Village of Arlington Heights
Conceptual Plan Review Committee
Community Room, 3rd Floor
Arlington Heights Village Hall, 33 S. Arlington Heights Rd.
November 9, 2022
6:15 PM

Temp File Number: T1789
Project Title: Car Wash Redevelopment
Address: 1007 E. Palatine Road
PIN: 03-20-201-001-0000

Temp File Number: T1778
Project Title: St. Viator Master Plan
Amendment
Location: 1213 E. Oakton Street
PIN: 03-29-210-006

1 PRELIMINARY SITE PLAN
SCALE: 3/32"=1'-0"

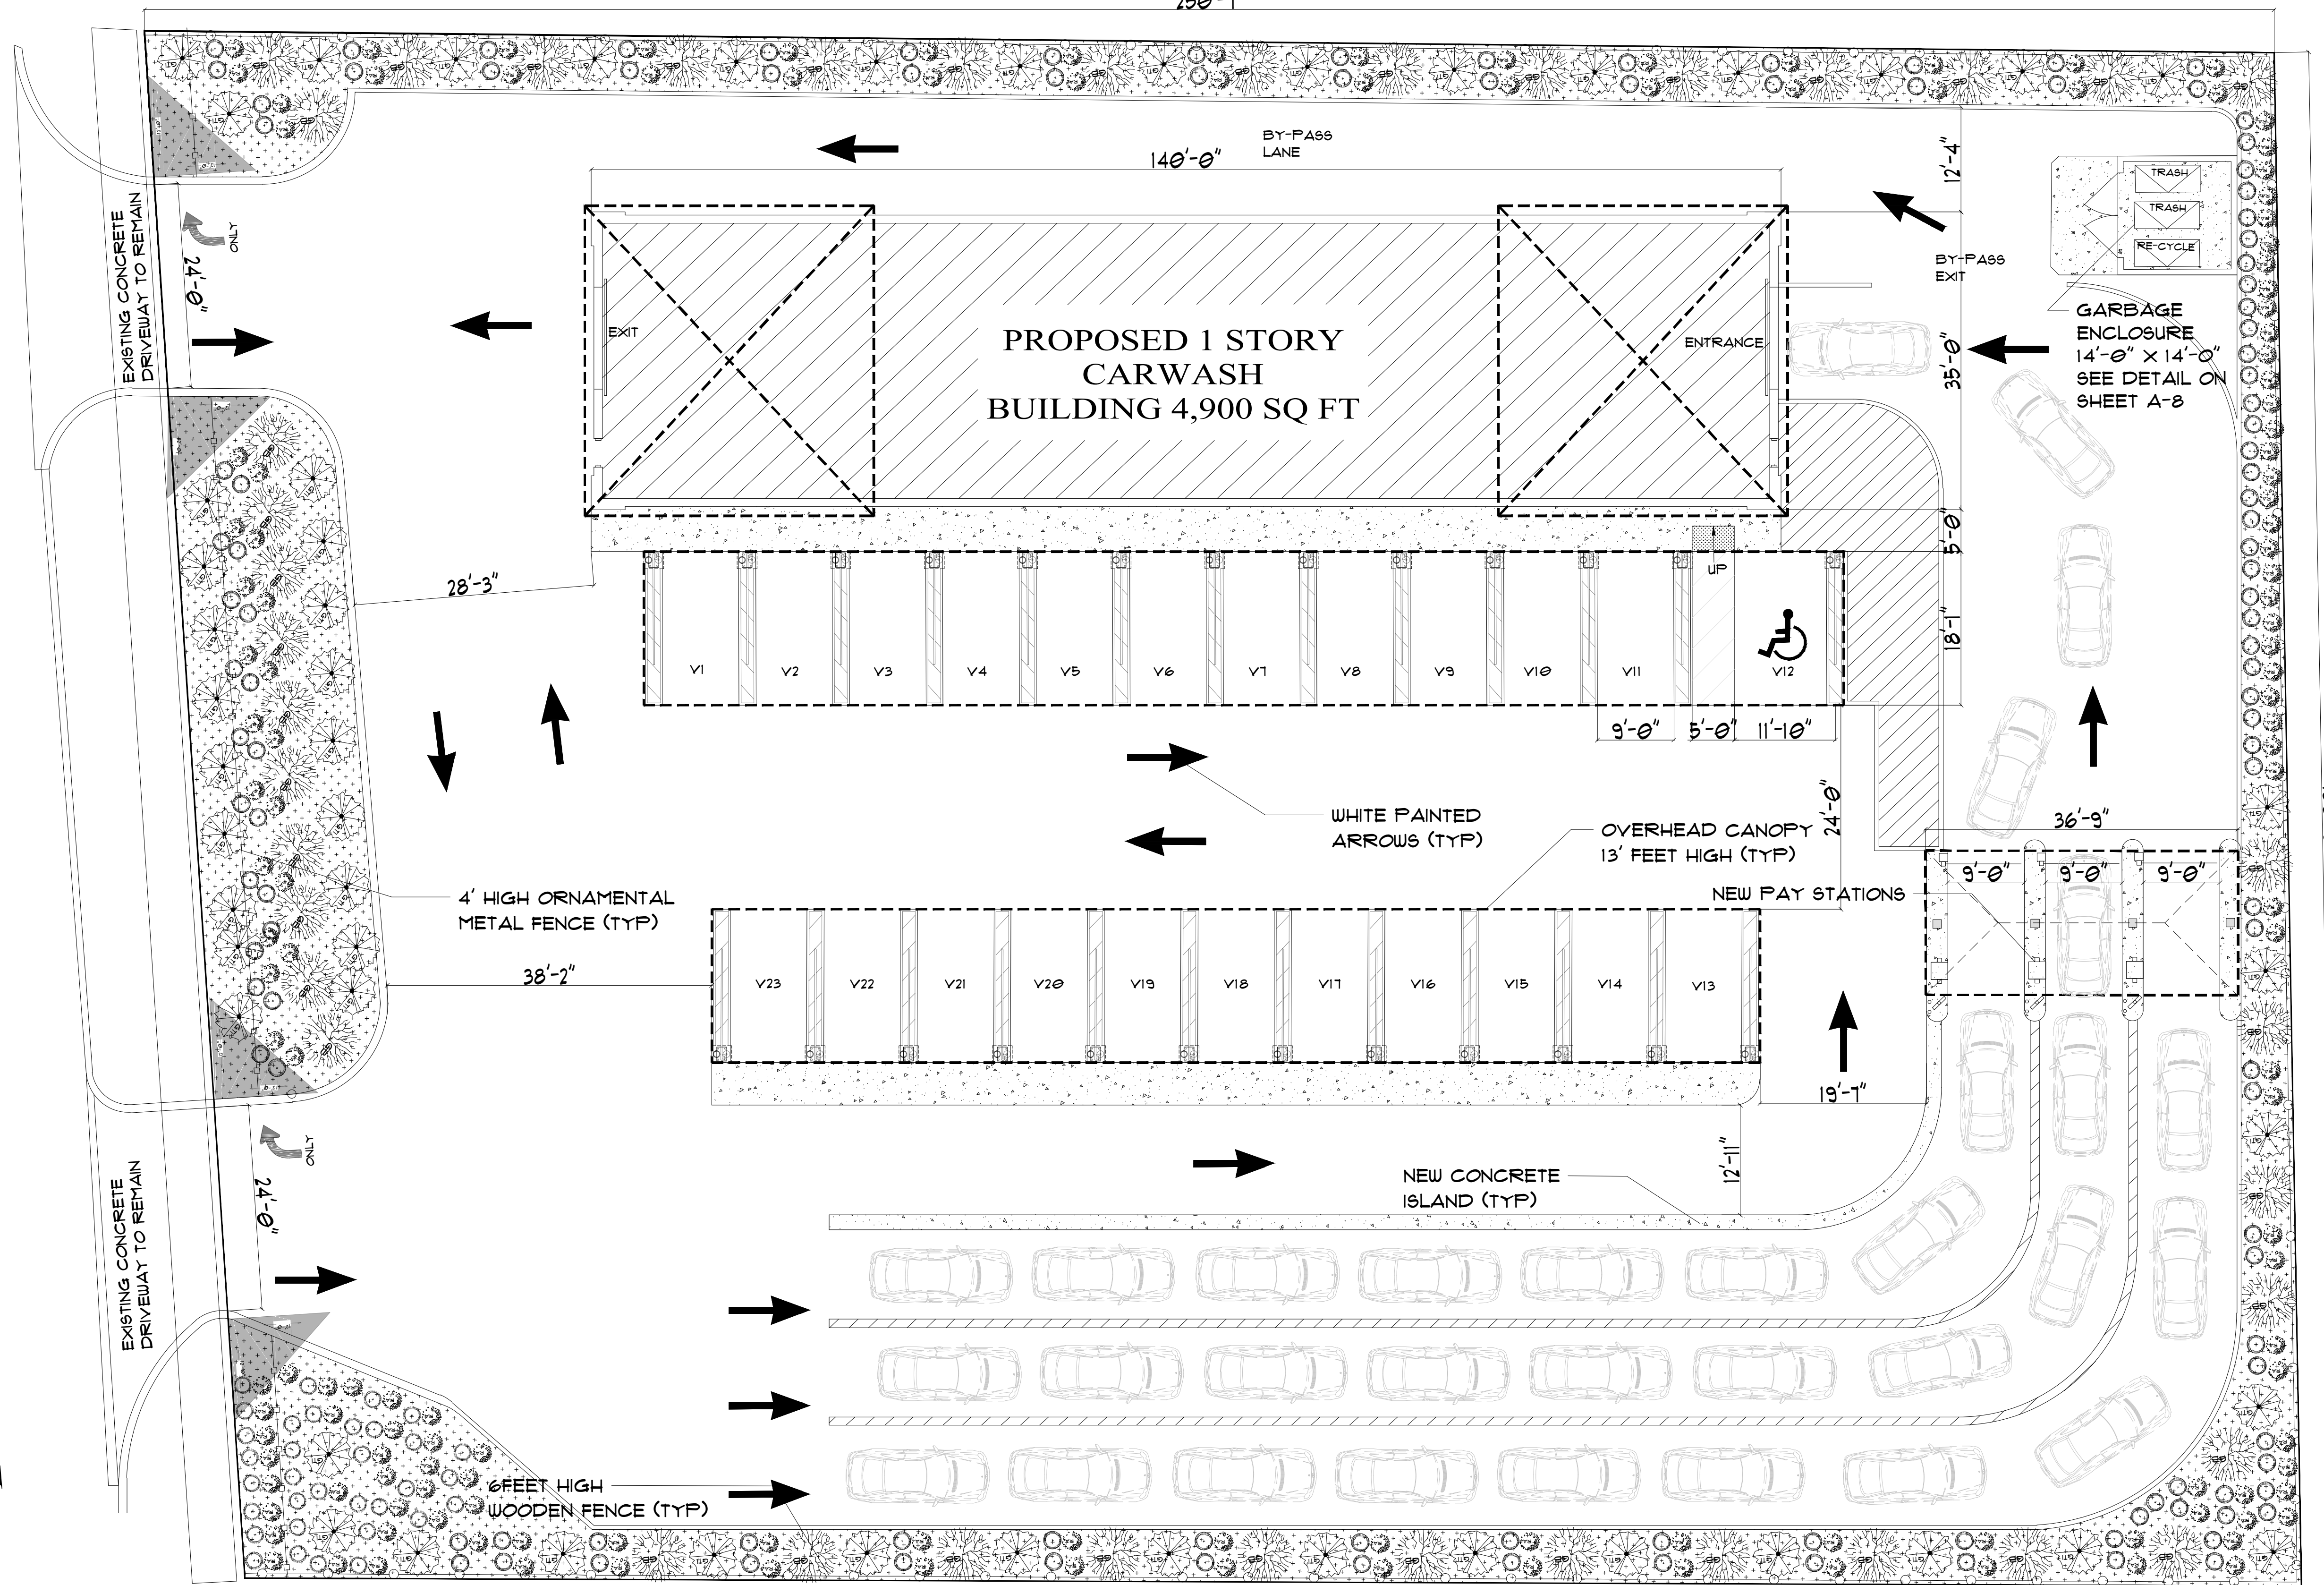
The petitioner is proposing a 4,900 square-foot car wash building, with 23 parking spaces and 20-22 vacuum stations. The Building Department had concerns during Staff Development Committee Review with respect to restroom, parking space, and vacuum station accessibility. As part of the Plan Commission Review process, the petitioner shall address these concerns to comply with applicable accessibility code regulations.

The concept plan is missing code-required landscaped islands at the end of each parking row, though it appears there would be sufficient space to add the required islands.

Three separate canopies are proposed to cover the vacuum areas, as well as shelter the pay stations. Code allows a maximum accessory structure size of 300 square feet, however the canopies are proposed to be a 2,385 square-feet, 2,735 square-feet, and 662 square-feet. Therefore, three variations would be required. The petitioner shall provide a

Design Commission Review will be required for the new commercial structure. Photometric plans will be required for new site lighting. An Auto-Turn exhibit showing the turning path through the site for Village fire apparatus shall be provided. The exhibit must show the apparatus maneuvering through the site in all possible directions of travel.

Staff have concerns regarding circulation within the site, as well as access to and from the site from the frontage road. The existing configuration of the driveways is enter-only at the eastern driveway, and exit-only at the western driveway. The access shown on the site plan does not match existing conditions. To accommodate two-way traffic at both access points, modifications will be needed. As Palatine Road is under IDOT jurisdiction, an IDOT permit for these modifications would be required. If stop control is proposed, detectable warnings will be required. Additional signage may be required by IDOT.

Sheet Title
SITE PLAN EXHIBIT

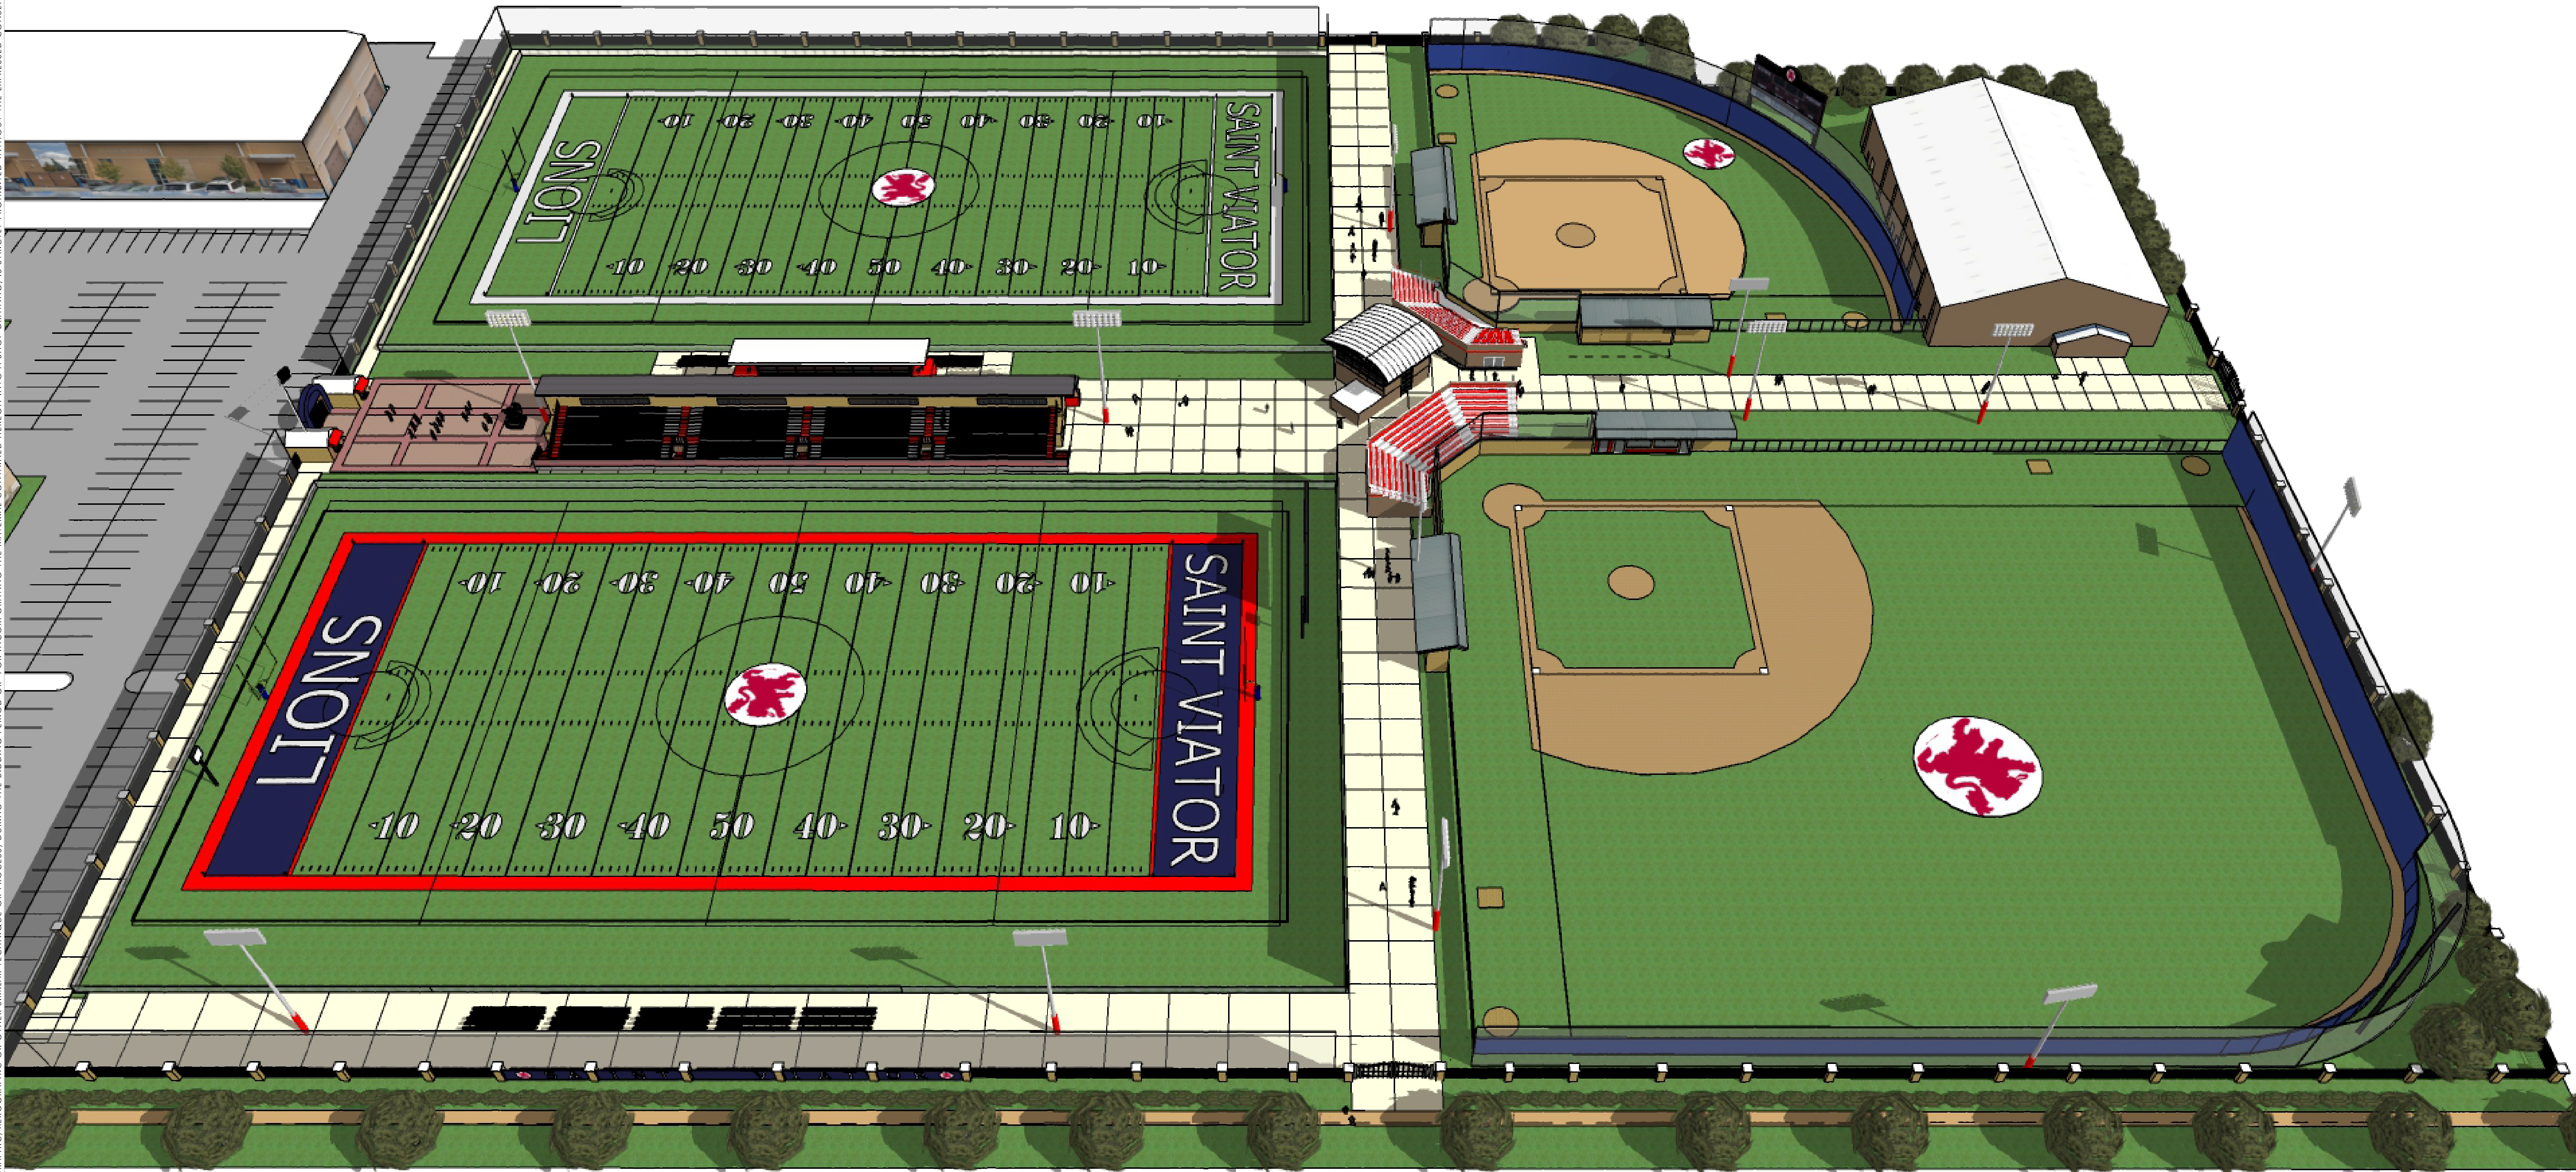
In order to properly classify each structure as either an accessory structure or primary building, details on size, use, height, and the appearance of all structures constructed as part of the athletic field improvements shall be required, including the grandstand and press box, concession stand, bleachers, fencing and athletic field walls, scoreboards, and the athletic building. Height, size, and locational variations may be required for these elements, which will be evaluated once detailed plans have been submitted. Furthermore, upon review of detailed plans, staff will review to determine if a Design Commission application will be required for the school building addition, athletic training building, and grandstand/press box.

Submission of a landscape plan, tree preservation plan, and photometric plan shall be required as part of Plan Commission review. Staff has concerns with the impact of the stadium lighting on the neighborhood. If approved, the stadium light systems and usage must be carefully designed to minimize glare and excessive spillover to neighboring properties.

The petitioner must provide details on the proposed safety netting, including product specifications, pictures of the proposed netting installed at other locations, and whether the netting would be removed during off-season times. Aesthetics of the netting, support structures, and the overall redevelopment of the existing open space must be evaluated.

The proposed athletic field improvements will have a significant impact on the existing traffic and parking demand generated by the subject property, which will need to be carefully evaluated as part of any formal review process. Per code, the petitioner must provide a traffic and parking study by a certified traffic engineer that assesses access (location, design, and Level of Service), on-site circulation, trip generation and distribution, drop-off and pick-up operations, parking (both onsite, on-street, offsite, and bus parking), and impacts to public streets. Data/surveys on peak parking demand during games at the existing Forestview location should be provided as part of the Plan Commission review process.
